PRODUCT BULLETIN

Additional Set Screws in Gauge Bodies

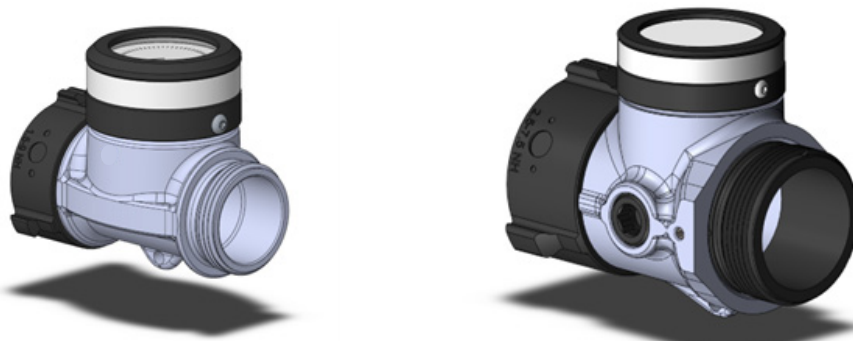
A set screw is added to each side of the In-Line Gauge Body to improve the internal stability of the gauge for longer gauge life. There is no change to function or overall dimensions.
